Exhibit "E"

2018 International Residential Code

North Central Texas Council of Governments Region

****Figure R602.6.1; delete the figure and insert the following figure:**

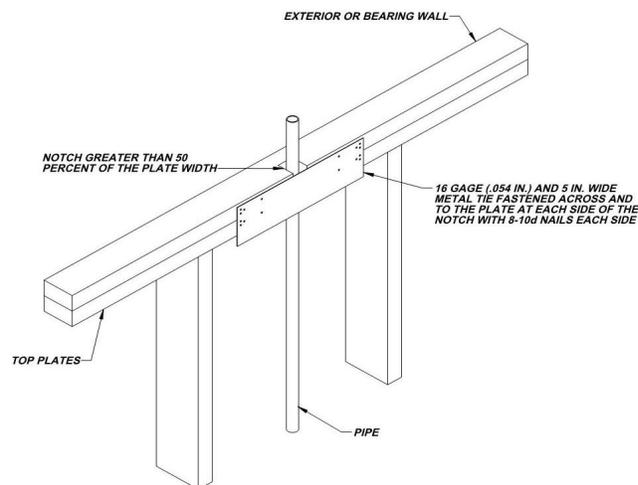
R602.6.1 Drilling and notching of top plate. When piping or ductwork is placed in or partly in an exterior wall or interior load-bearing wall, necessitating cutting, drilling or notching of the top plate by more than 50 percent of its width, a galvanized metal tie not less than 0.054 inch thick (1.37 mm) (16 Ga) and 4 ½ inches (38) mm 5 inches (127 mm) wide shall be fastened across and to the plate at each side of the opening with not less than eight 10d (0.148 inch diameter) having a minimum length of 1 ½ inches (38 mm) at each side or equivalent. Fasteners will be offset to prevent splitting of the top plate material. The metal tie must extend a minimum of 6 inches past the opening. See figure R602.6.1. *{remainder unchanged}*
